Report / Decision on Change or Cancellation of Condition(s)
(Section 127)

s127 Application number: RMA/2022/344
Original application number: RMA/2018/2326
Applicant: Papanui Properties Limited
Site address: 84 Langdons Road
Legal description: Pt Lot 1 DP 13545, and Lots 1 & 2 DP 458643
Zoning: Commercial Retail Park
Overlays and map notations: Flood Management Area, Liquefaction Management Area, Collector Road, Christchurch International Airport Protection Surfaces
Activity status: Discretionary activity
Description of application: Change of conditions pursuant to Section 127

Block C would now be laid out as follows (original layout outlined in red):

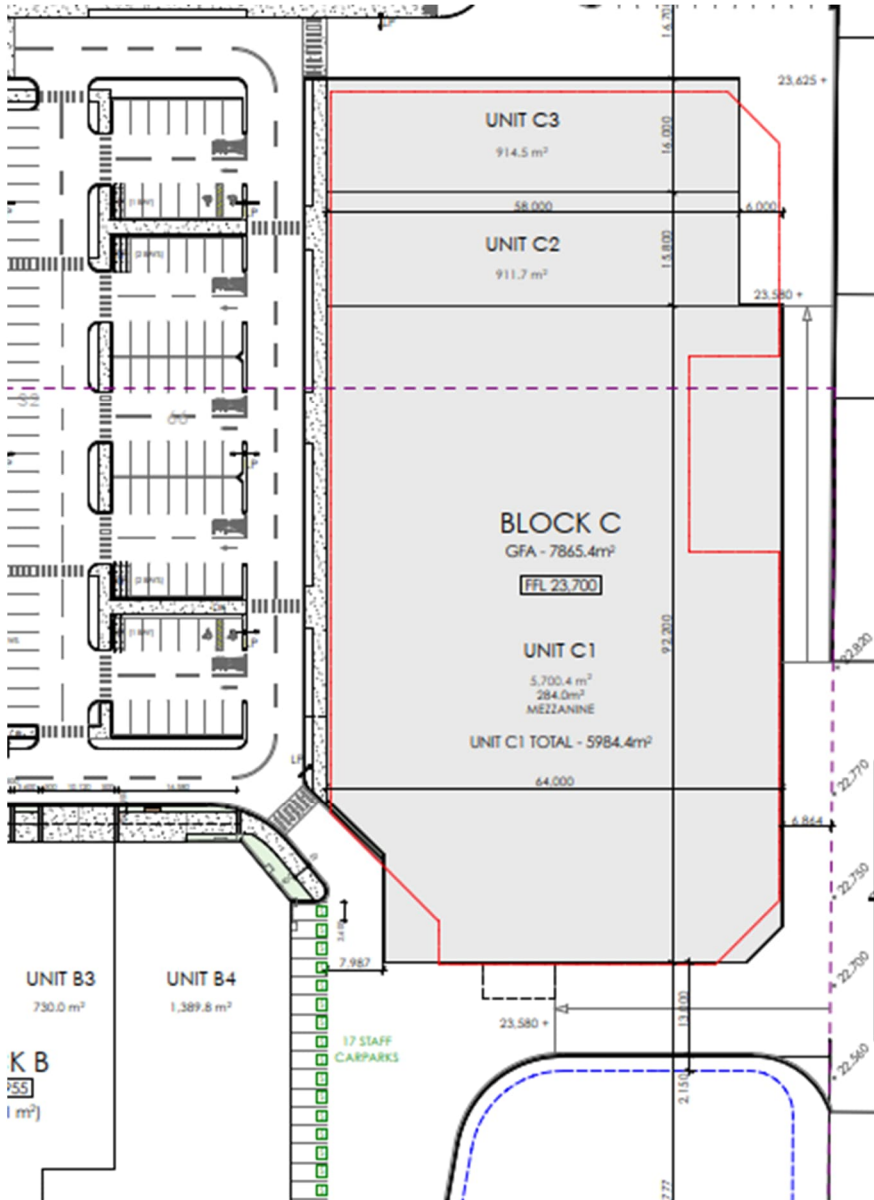
The significant differences in Block C are:

- breaking it into three tenancies;
- some additional floor area in the north east and south east and redistribution of a floor area in the western;
- Addition of a mezzanine floor or 284m²; and
- The approved GFA under RMA/2018/2326 was 6947.2m². The applicant now seeks that this floor area be 7865.4m²

Figure 1: Surveyed Site Traffic Distribution (% of site generation)

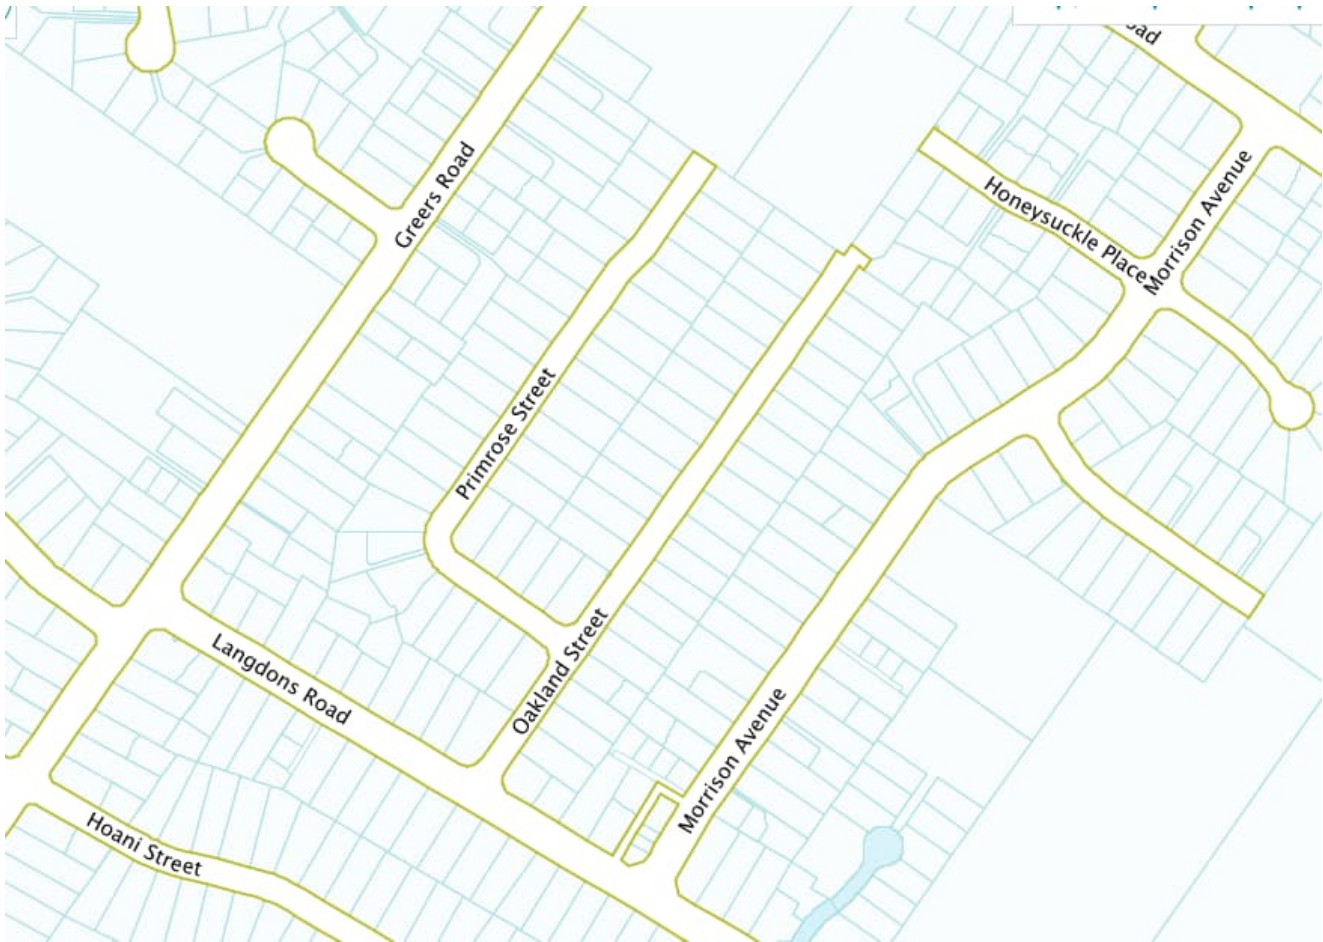
It is clear that the significant majority of trip generation is projected to move to and from the east along Langdons Road. Comparatively few vehicle movements are through the Greers / Langdons intersection or through Morrison Avenue. The large majority of traffic that is heading in a westerly direction is projected to turn left into Langdons Road.

The right turn from Langdons Road to Greers Road accommodates approximately 2% of site generated traffic. Combined with the Morrison Avenue exit volume, that is 4% travelling north from the site via those two movements.

Also of note is the large volume that exits the site to the east (38%), at a higher traffic volume than enters from that direction. As we set out in our earlier memo, that is largely anticipated and the CAST modelled assessment from the original Stage 2 assessment of potential rat running through Morrison Avenue to access Sawyers Arms Road / Main North Road intersection has not eventuated. (Emphasis added)

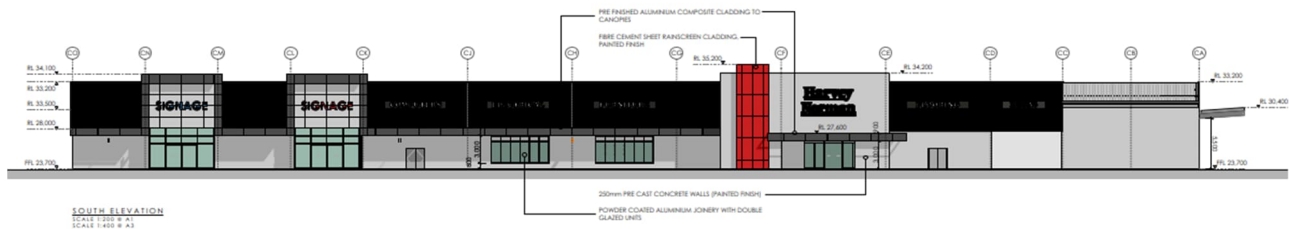
The significant difference is in the south elevation of Block C with addition of two entrance ways and more visually interesting detail in the façade.

I consider that there will be no adverse amenity effects associated with the reconfiguration of Block C.
